**MONTGOMERY COUNTY HISTORIC PRESERVATION COMMISSION**  
**STAFF REPORT**

<b>Address:</b>	10212 Montgomery Ave., Kensington	<b>Meeting Date:</b>	1/10/2024
<b>Resource:</b>	Primary One Resource <b>Kensington Historic District</b>	<b>Report Date:</b>	1/3/2024
<b>Applicant:</b>	Warner Circle Mansion Condominiums, LLC (Karl Voglmayr, Agent)	<b>Public Notice:</b>	12/27/2023
<b>Review:</b>	HAWP	<b>Tax Credit:</b>	Partial
<b>Permit No.:</b>	1032588 REVISION	<b>Staff:</b>	Dan Bruechert
<b>Proposal:</b>	Post-approval revisions for comprehensive rehabilitation, new addition, site alterations and grading

## WARNER MANSION RENOVATION & ADDITION – HPC REVIEW

SHEET SIZE: E1 - 42" X 30"  
SHEET NUMBER:  
**A002**

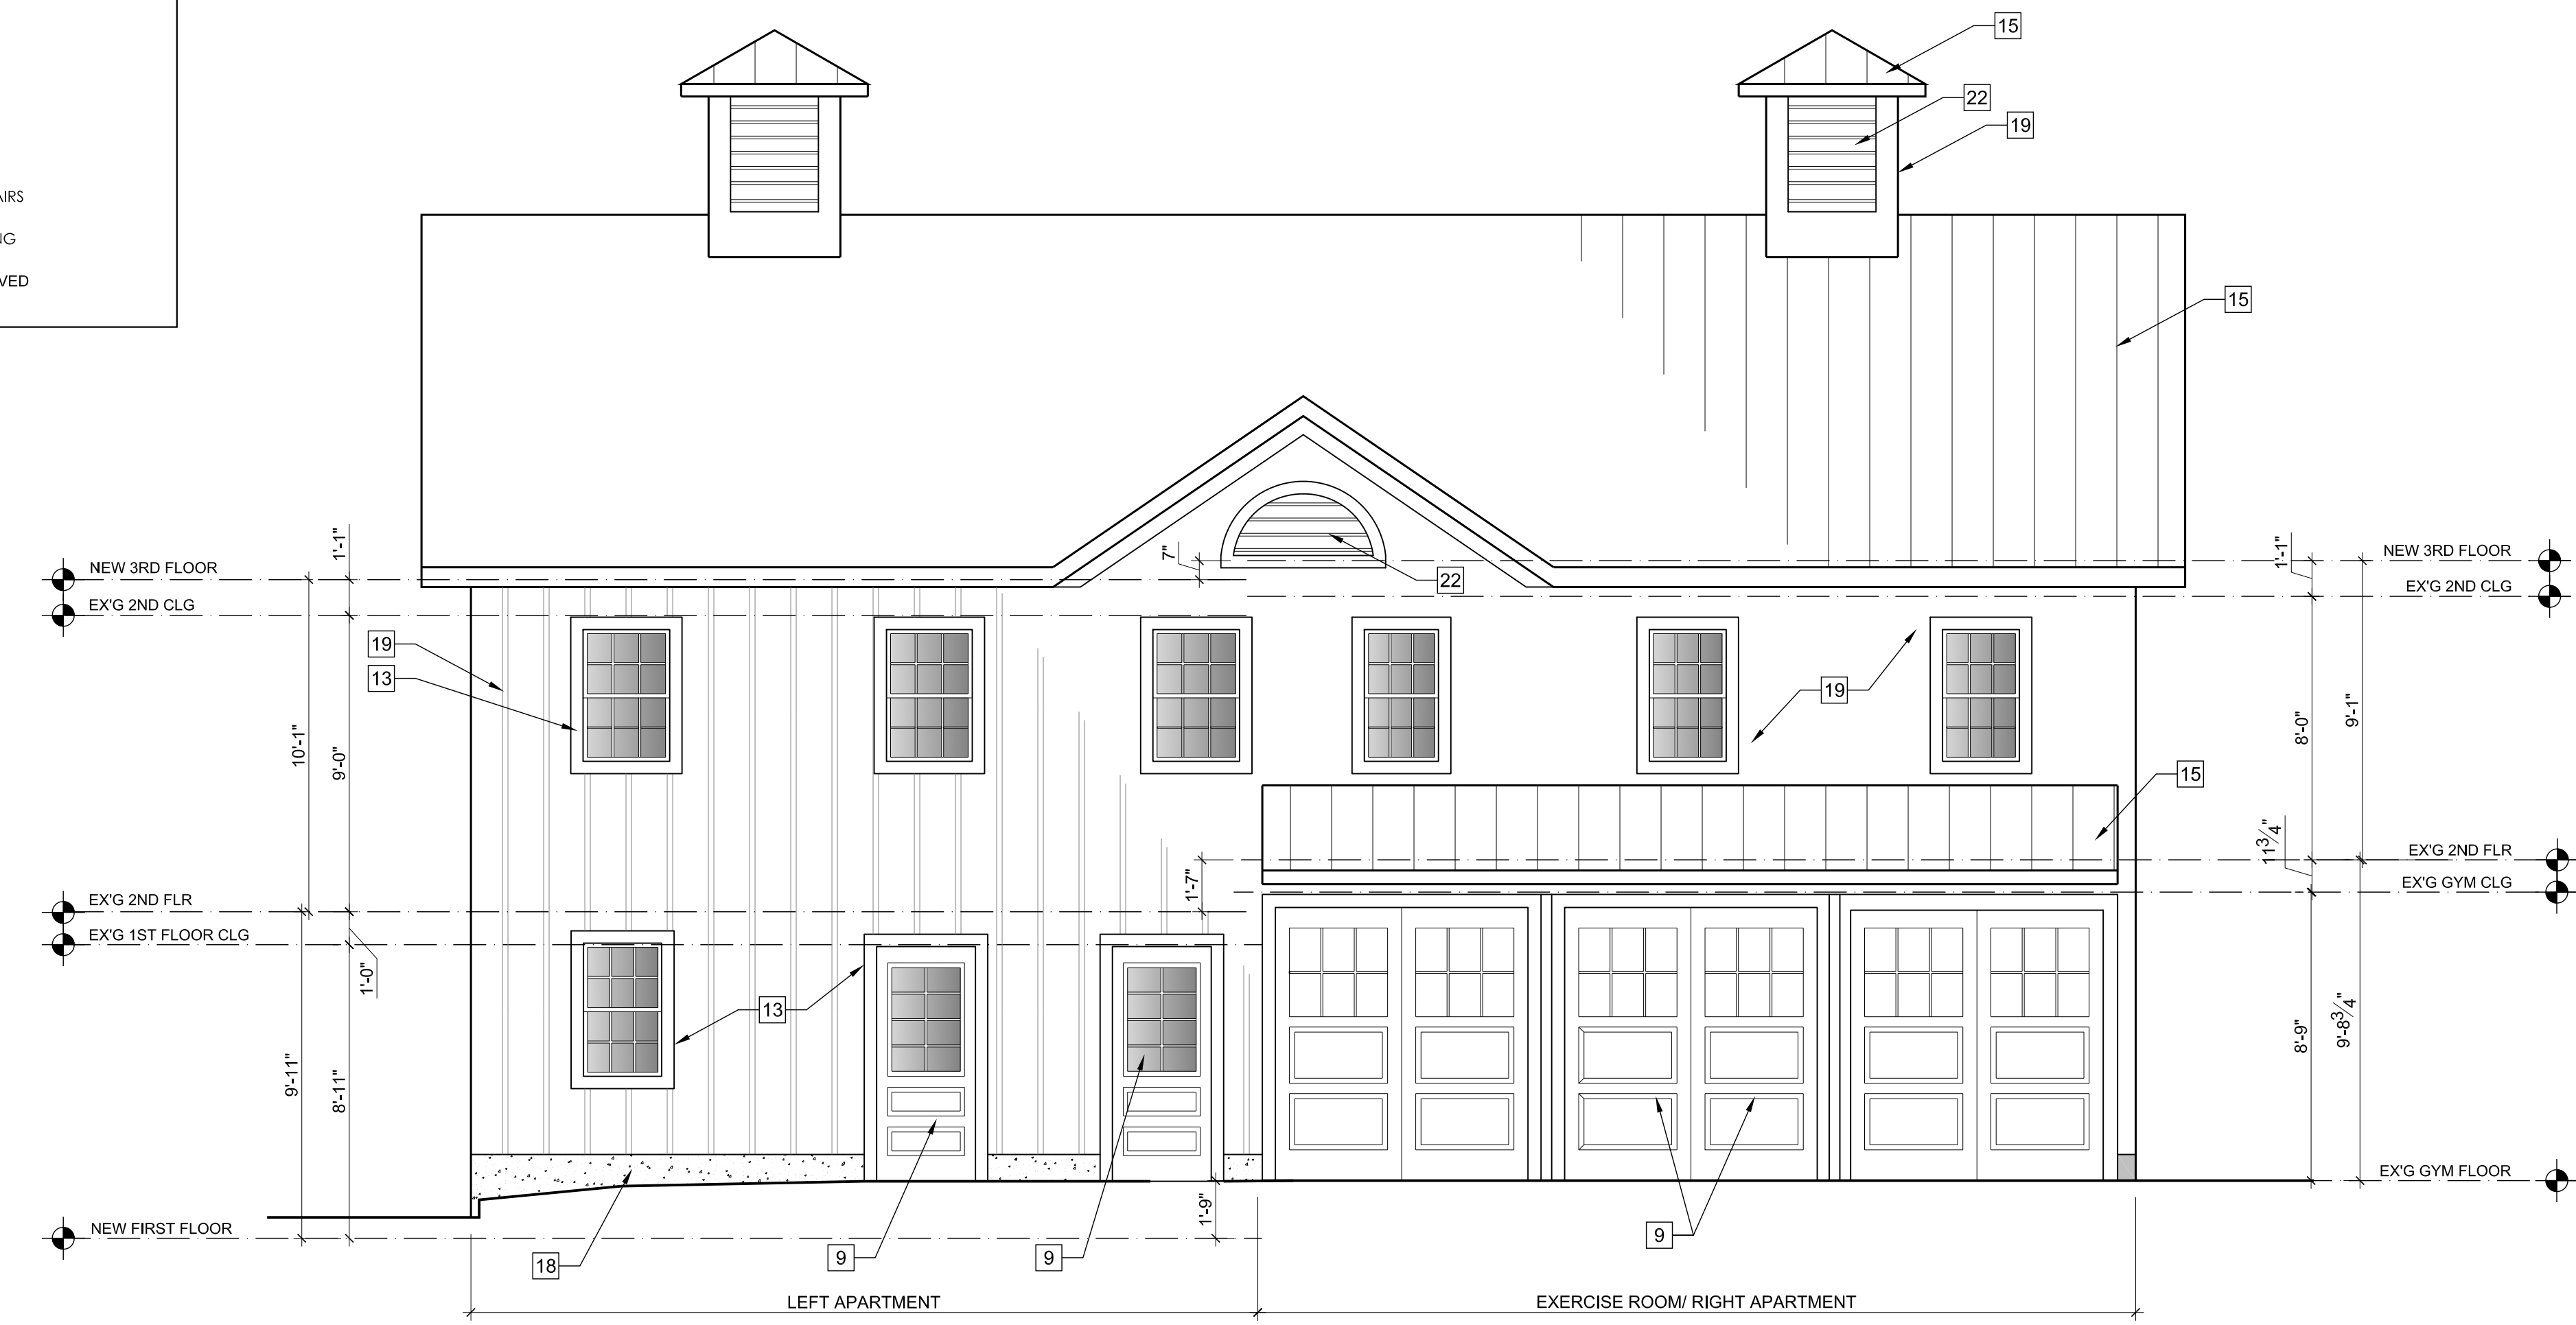
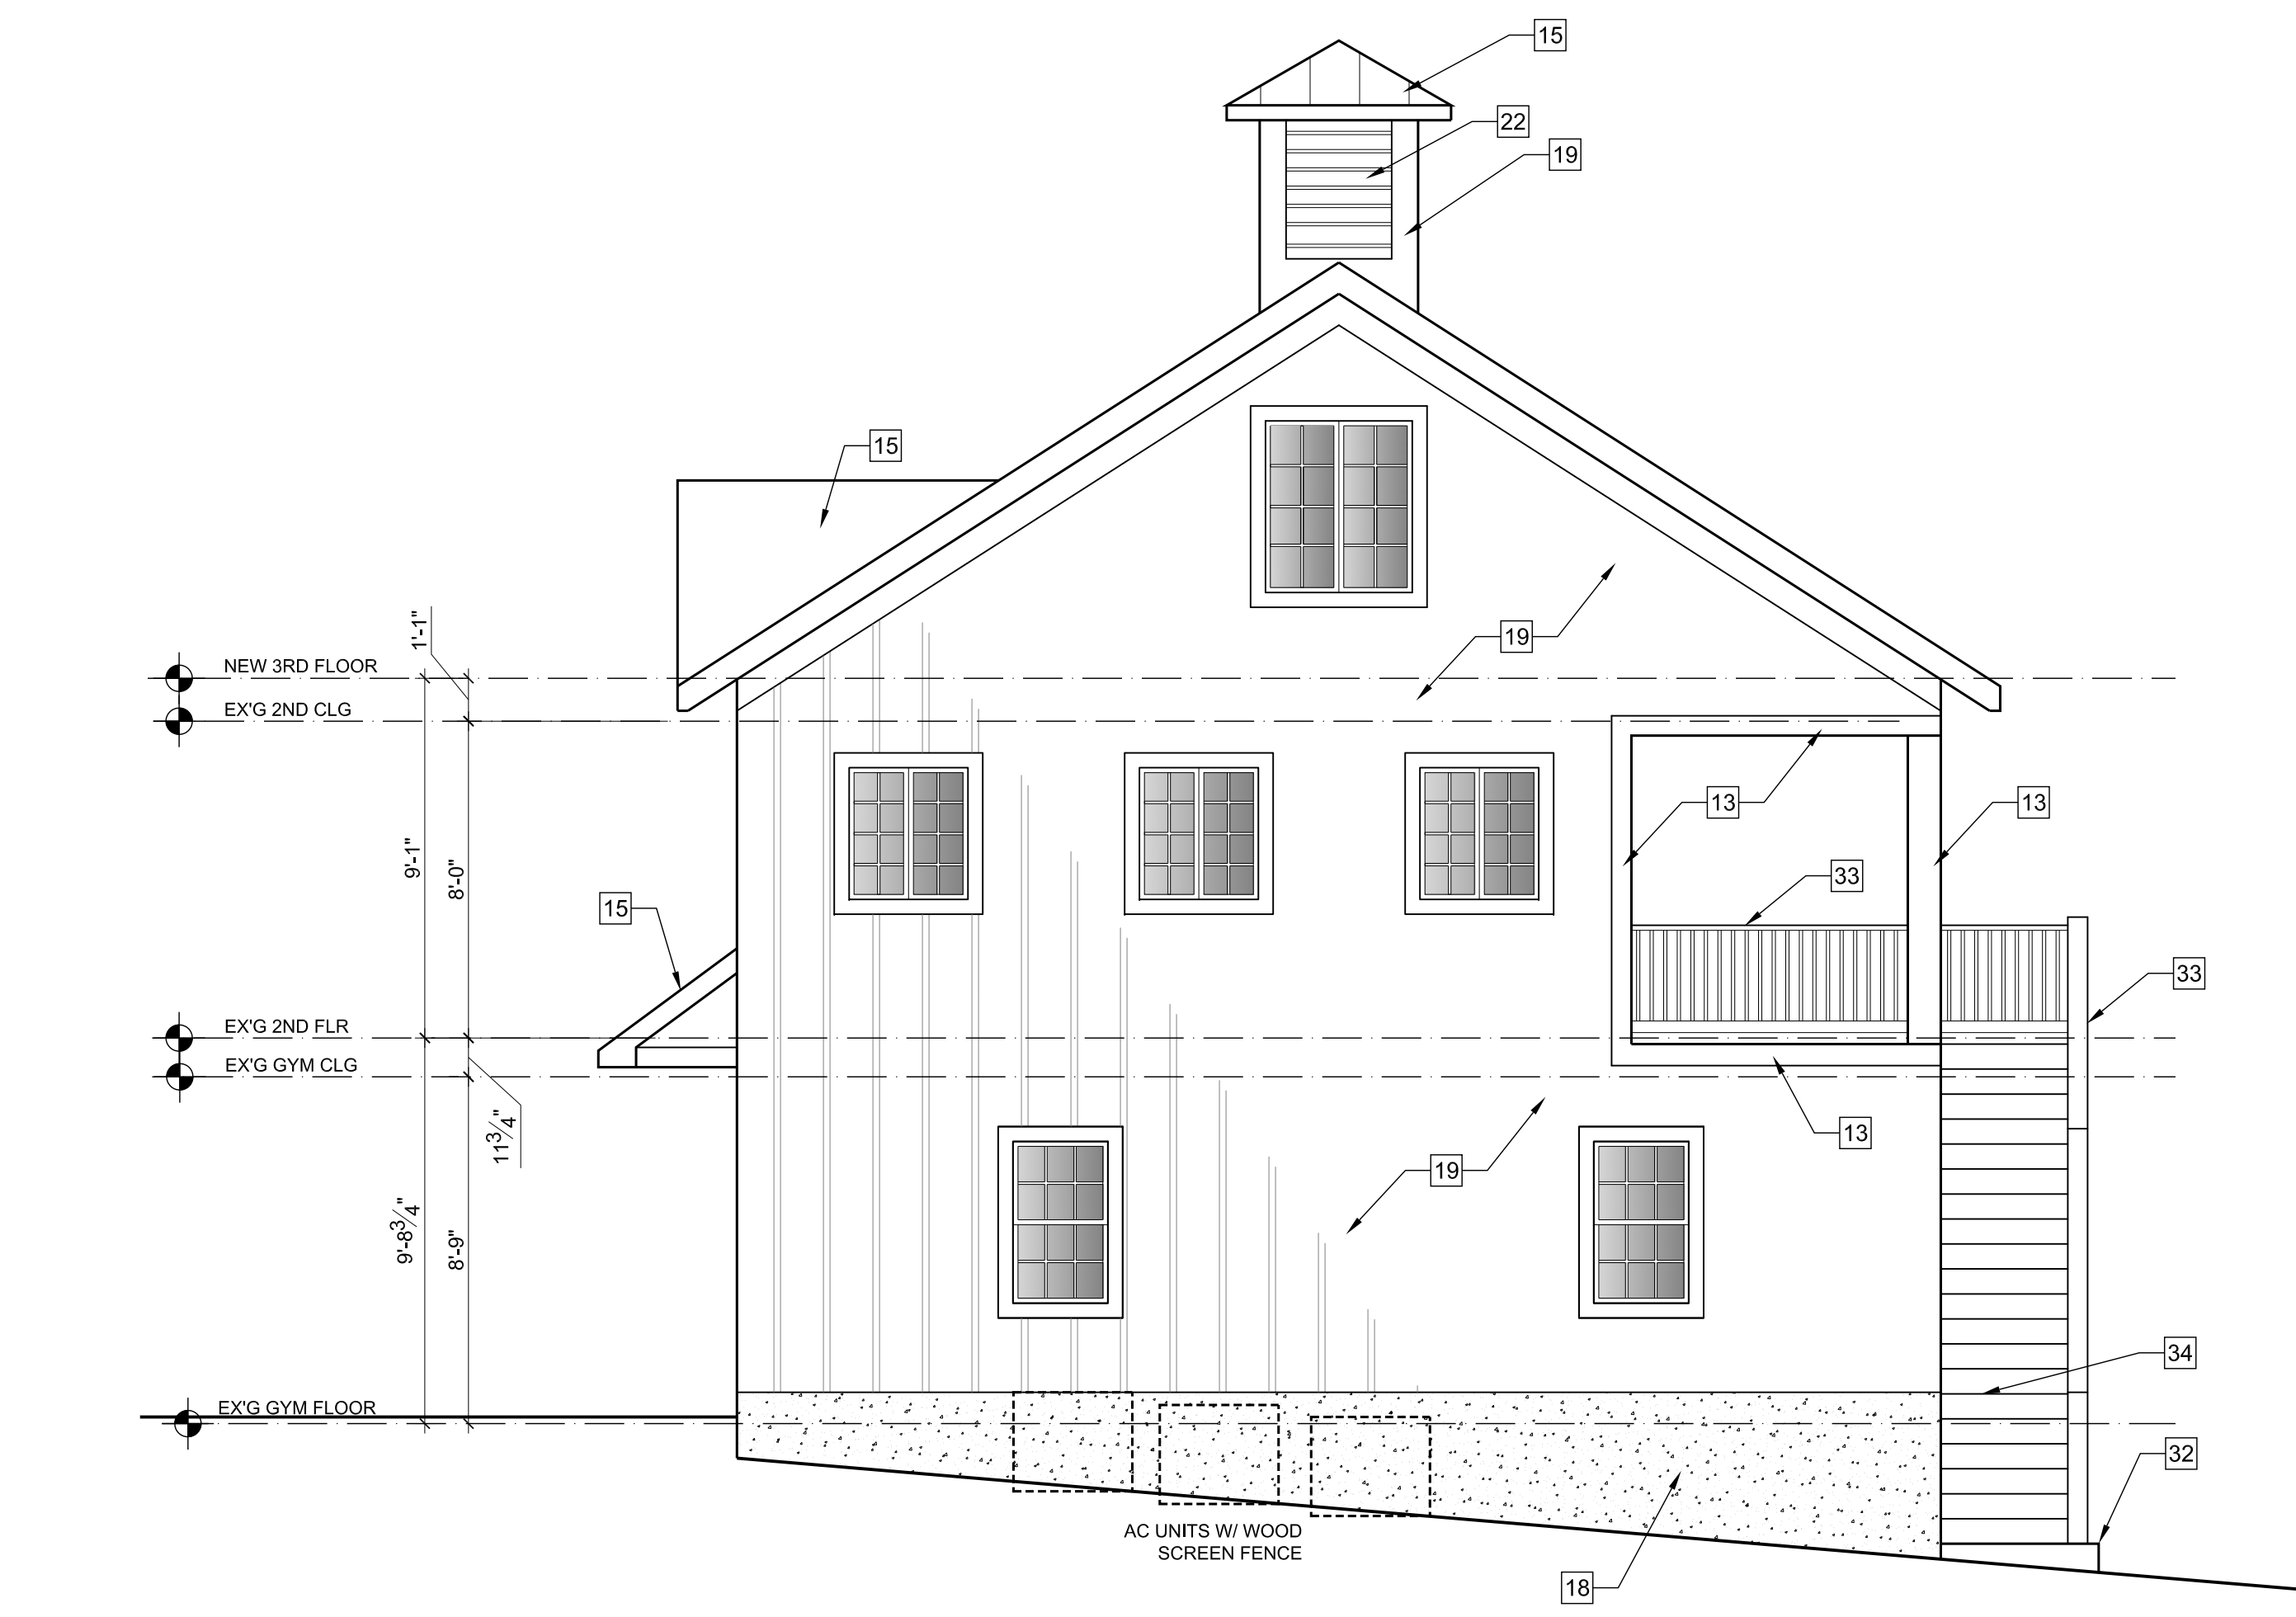
6. 3<sup>rd</sup> Floor Window Raised, enlarged for egress – The existing opening on the west elevation has a louvered opening. The applicant proposes removing the louvers and installing a pair of eight-light casement windows which will satisfy code requirement for egress. Staff finds removing virtually all of the louvered openings has the potential to negatively change the character of the historic carriage house contravening 24A-8(b)(2) and Standard 2. Staff recommends the HPC not allow this change and recommends the applicant consider alternative solutions, such as a skylight, on the south roof slope or other floorplan revision.

8. 3<sup>rd</sup> Floor Window Raised – As with the 3rd-floor window on the west elevation (#6, above), the applicant proposes to remove the louvered opening and install a pair of 8-light casement windows in the opening. The previous HAWP approval included installing a large sash window in the opening. However, the sill of that window appears to be too close to the floor (see *Figures 2-4*, below). . Based on the drawings submitted, Staff cannot evaluate the size of the proposed window compared to the previous approval. Staff finds the relocated window negatively impacts the fenestration on the east elevation and recommends the HPC not approve the alteration.

1. For the Carriage House, some windows have been enlarged or slightly re-positioned. See the clouded areas on sheet A002.
2. The solar panels have been deleted from the south Carriage House roof as shown on Sheet A002.

3. The existing ramp has been deleted from the south side of the Carriage House as shown on Sheet A002. The concrete is in a state of extreme disrepair and code would require guardrails of some kind on each side if rebuilt or repaired.

2. The approval of these revised work items does not extend to the proposal to remove the louvered opening on the third floor and convert it into a window (work item #6). This opening should be retained, though glazing may be installed behind the louvers. If necessary alternative means of egress can be accommodated including a skylight on the south roof slope. Revised elevations and floorplans showing this condition has been satisfied need to be submitted to Staff to verify this condition has been satisfied.

3. The approval of these revised work items does not extend to relocating and reconfiguring the 3rd-floor window on the east elevation (work item #8) from the June 16, 2023 HAWP approval. As with work item #6, the opening size and placement need to be preserved.
